106 JAMESTOWN AVENUE

CDR PROJECT APPLICATION FORM

RE: ZP-2026-001178-- 106 Jamestown Avenue

TYPICAL FLOOR PLAN

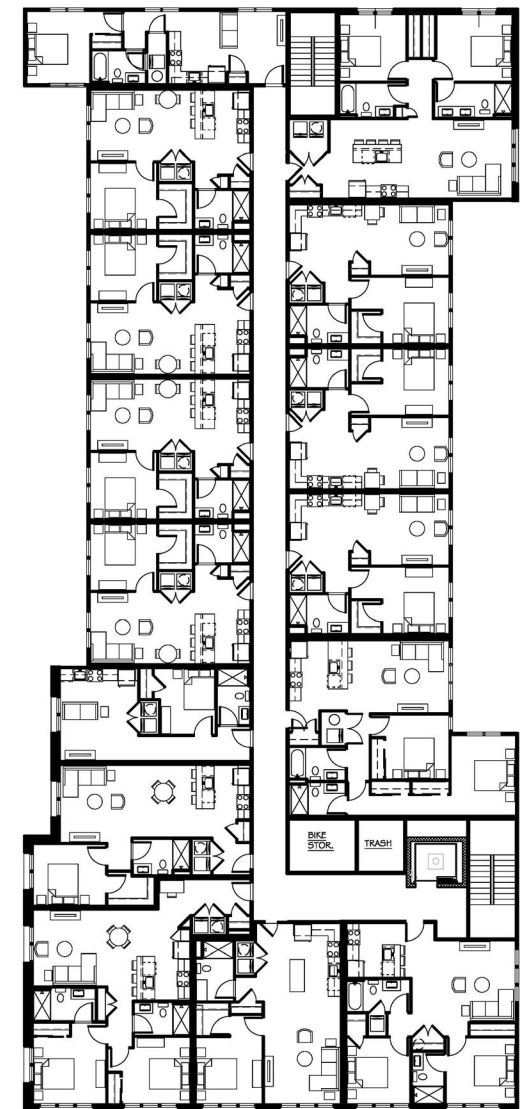
We've added a typical floor plan to the presentation where we show that there are no bedrooms with windows in the 8' side yards facing the rail line.
